SITE INSTRUCTION # 10**Project Name: Hampton Manor (25 Baker Hill Boulevard) - Stouffville****Project Number: 20140490****Vince Staffieri****May 11, 2018****Royal Pine Homes****3550 Langstaff Road, Suite 200****Woodbridge, Ontario L4L 9G3****via email: vince@royalpinehomes.com**

A. REFERENCE:

- .1 Drawings S1-05 and S1-06.

6TH FLOOR FRAMING PLAN
As indicated
S1-05

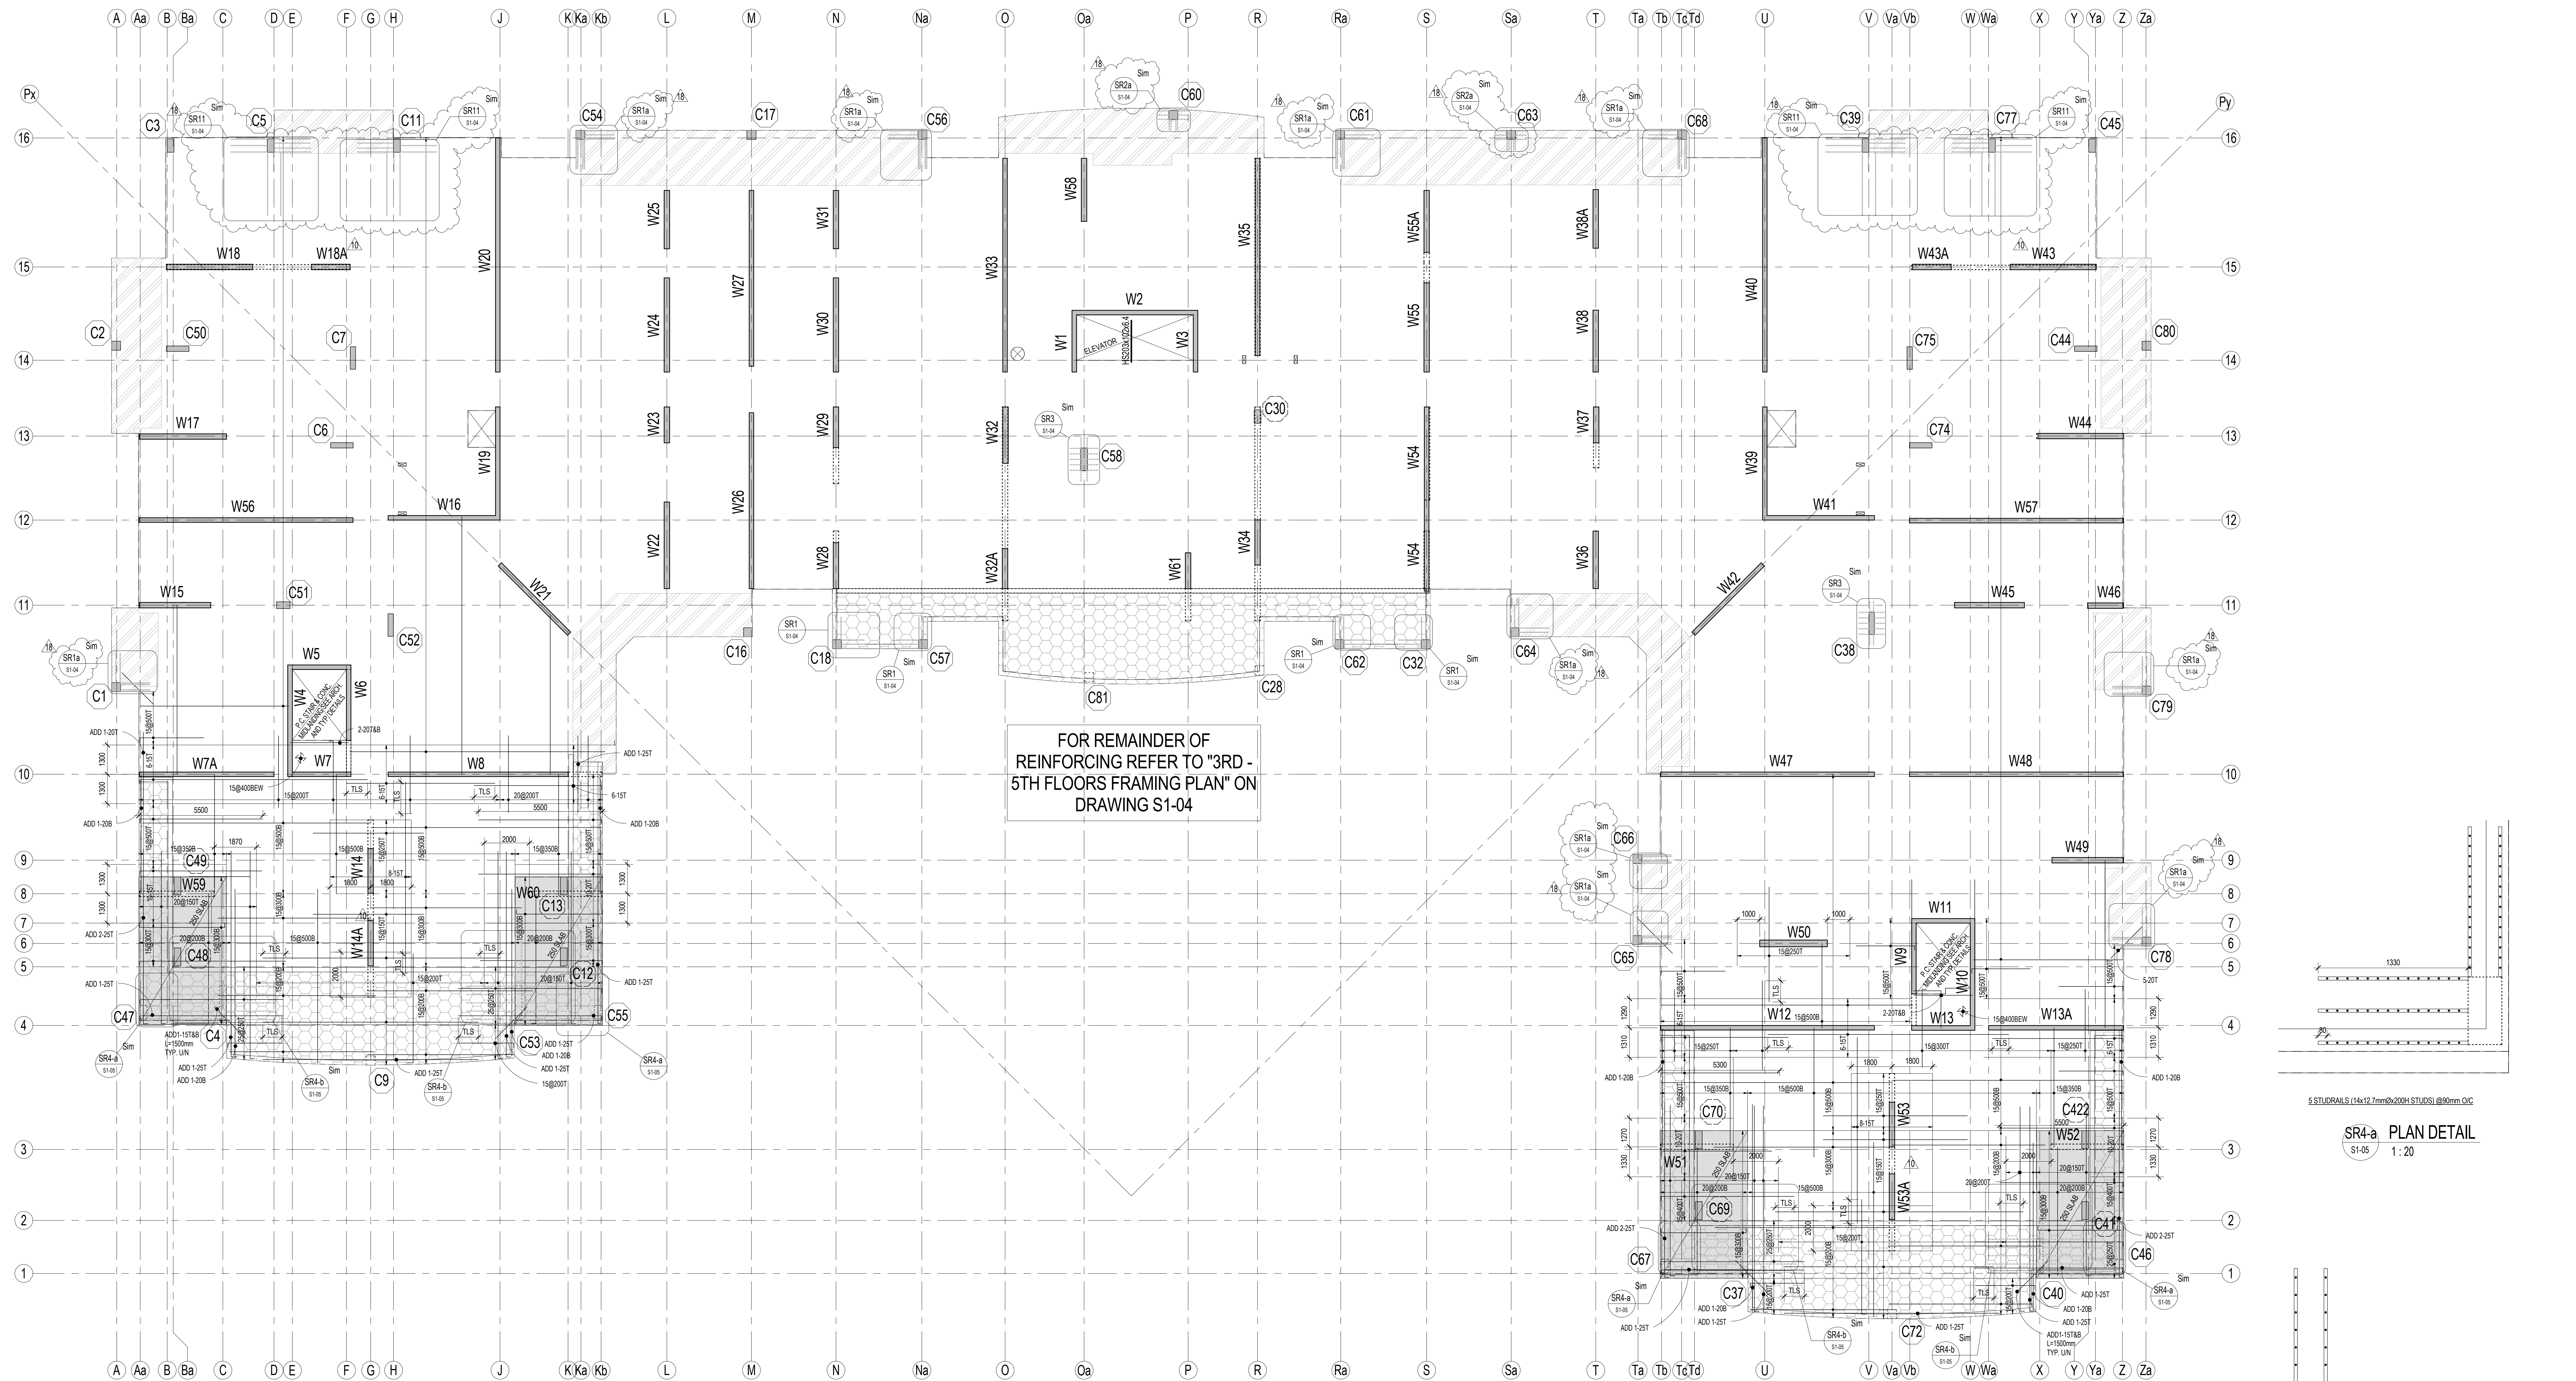
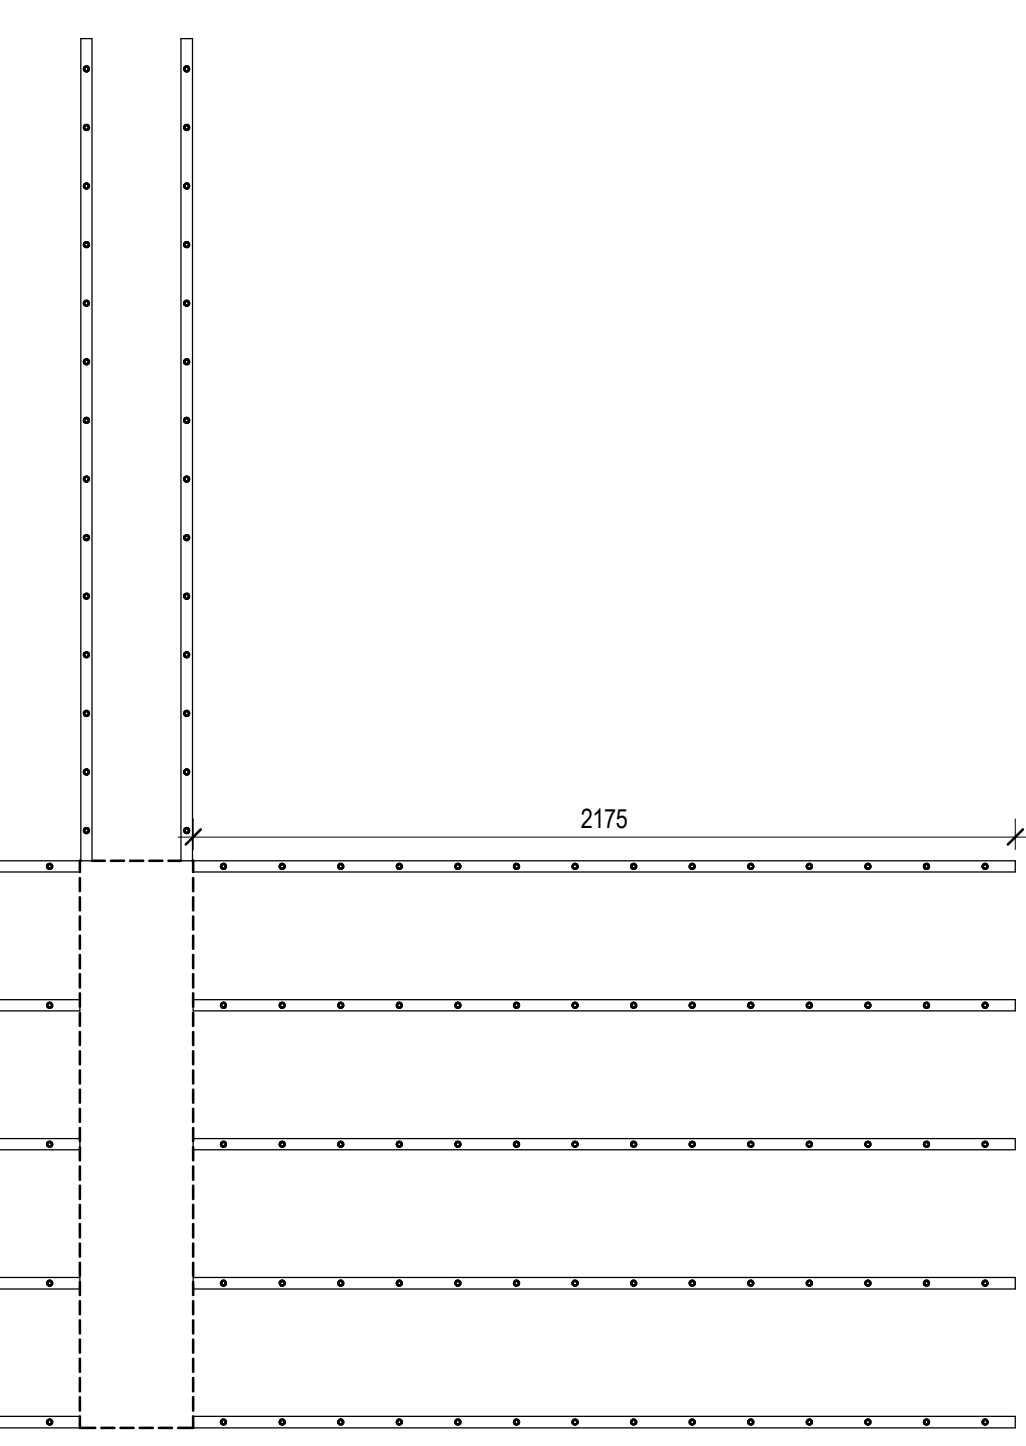
- .1 Revise Studrail reinforcement for slabs at Levels 6 and 7, as indicated.

- .1 To suit floor openings required for precast concrete cladding and M&E services.
